Urgent Field Safety Notice

GD4500 Rev B

Getinge is initiating a field safety correction with regards to Washer-Disinfector of GETINGE Getinge 46-Series (46T excluded) with PACS 300/350 control.

Figure 1: vent hole added on top of manifold to prevent trapping of air.

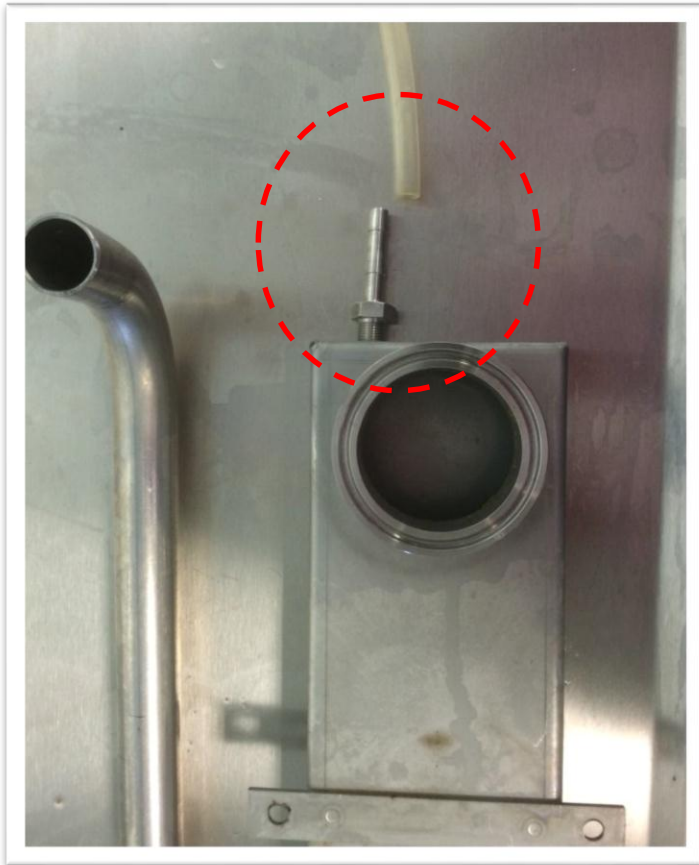
We have however now after performing detailed root cause analysis identified the problem as insufficient water flow throughout the manifold due to formation of air-pockets where sedimentation may occur. Use of detergents that are not recommended might also have negative impact.

- Cleaning of the manifolds.
- Adding ventilation-hole at the top of the manifold and linking it to the chamber i.e. preventing the formation of any air-pockets and secure a continuous water flow. See details in appendix 1
- Getinge will amend the instruction for use regarding the use of detergents, including a list of recommended detergents.
